Access Compliance Report

Public Rights-of-Way

Intersection ID: 19937	Main Street: S_TRYON_ST	Cross Street: THORNFIELD_RD	Location: NW
ADA ID: F88762574000	Ramp Type: BlendTrans1	Initial Pass/Fail: Pass	Overall Compliance: No
		Severity Score: 0

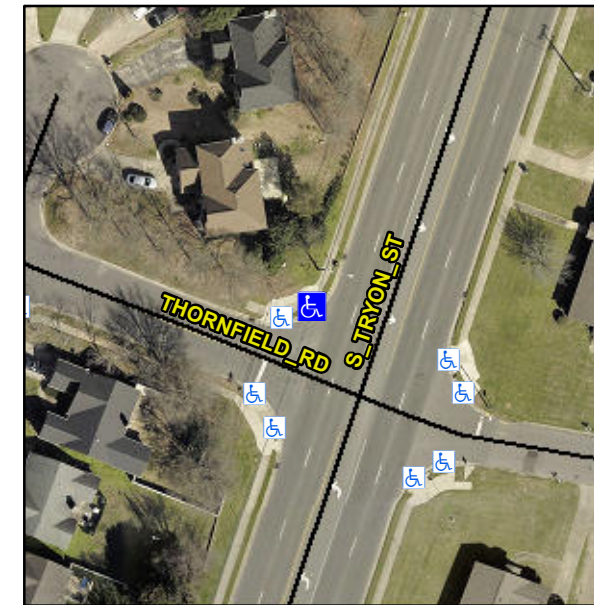
Not Found, R305.2

Compliance	Description	Data	Compliance	Description	Data
N/A	Ramp Length (in)	91.0	Yes	BlendTrans Slope (%)	5.0
Yes	Ramp Width (in)	48.0	Yes	BlendTrans XSlope (%)	1.5
N/A	Flare Type LT	Sloped	N/A	Flare Type RT	Sloped
N/A	Flare Slope LT (%)	2.0	N/A	Flare Slope RT (%)	6.4
N/A	Flare Traversable LT?	No	N/A	Flare Traversable RT?	No
Yes	Landing Length (in)	48.0	Yes	DWS Provided?	Yes
Yes	Landing Width (in)	48.0	Yes	DWS Contrast?	Yes
Yes	Landing Slope (%)	1.0	Yes	DWS Length (in)	24.0
Yes	Landing X Slope (%)	1.4	Yes	DWS Full Width?	Yes
N/A	Landing Curb? (Y/N)	No	No	DWS Offset (in)	4.5
N/A	Shared Landing?	No			
Yes	Gutter Ponding?	No	Yes	Gutter Slope (%)	1.5
Yes	Gutter Lip Ht (in)	0.0	Yes	Gutter X Slope (%)	1.6
N/A	Painted X Walk1?	No	N/A	Painted X Walk2?	No
	X Walk 1 Direction	To S		X Walk 2 Direction	To E
	X Walk 1 Width (in)	N/A		X Walk 2 Width (in)	N/A
	X Walk 1 Slope (%)	1.6		X Walk 2 Slope (%)	0.4
	X Walk 1 X Slope (%)	3.5		X Walk 2 X Slope (%)	1.8

N/A	Ramp inside XWalk1?	N/A	N/A	Ramp inside XWalk2?	N/A
	Road Slope (%)	1.2		Clear Space?	Yes
	Road X Slope (%)	0.2	N/A	Clear Space to XWalk (in)	N/A
Yes	Any Obstructions?	No	Yes	Storm Grate/Utility Hazard?	No
	Obstruction Type			Storm Grate/Utility Type	
		N/A			N/A
			Yes	Surface Condition? (G/P)	Good
			No	Curb Slope (%)	9.0

Remove & Replace Curb Ramp With Two New Directional Ramps or Equivalent.
